PCN20150518001

**Conversion to smaller reel (13" to 7") and associated packing materials
on Selected QFN Devices currently shipped in 13" reels
Final Change Notification**

Date: 5/26/2015
To: MOUSER PCN

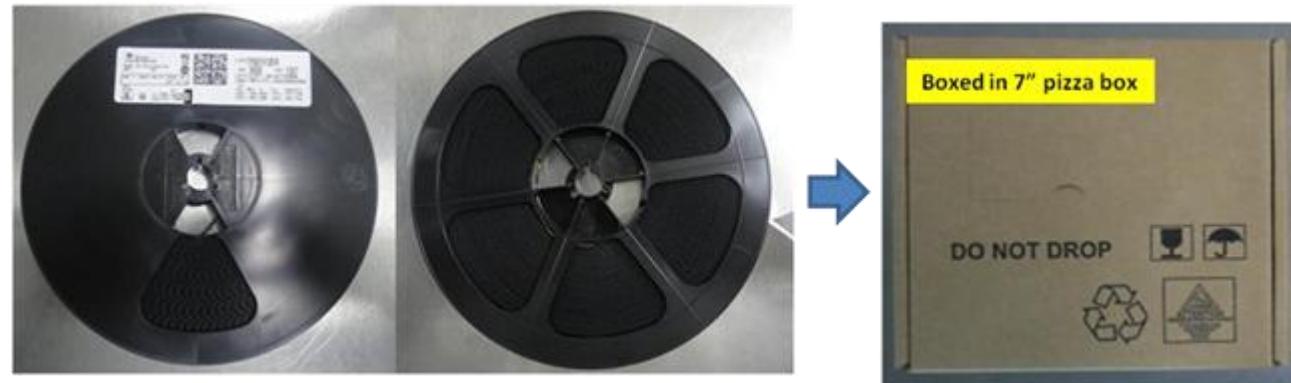
Conversion to a smaller reel size for selected product currently shipped in 13" reels with small reel quantities. The Moisture Barrier Bag (MBB) and pizza box will be switched to accommodate the smaller reel size. All new packing materials are qualified and currently in use for other products. Pack material differences are shown below:

Current Packing – 13 inch reel diameter

Proposed Packing – 7 inch reel diameter

Pack BOM	From	To
Reel Diameter	13"	7"
Pizza Box	4041330	4206831
